Access Compliance Report Public Rights-of-Way (Curb Ramps)

Intersection ID: 11195Main Street:DELGANY_DRCross Street:GLENVILLE_AVLocation:NEADA ID: AFB73CECB514Ramp Type:BlendTrans1Initial Pass/Fail:FailOverall Compliance:NoSeverity Score:10

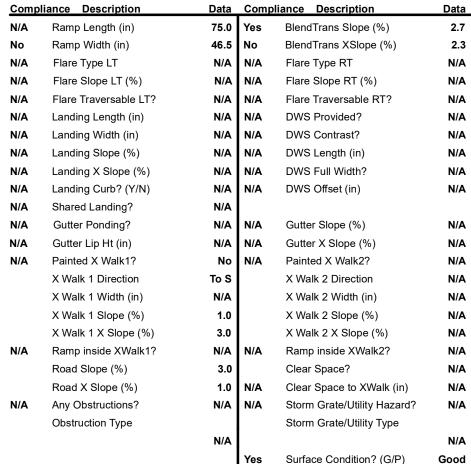
Not Found, R304.5.1, R304.5.3

Remove & Replace Curb Ramp With Two New Directional Ramps or Equivalent.
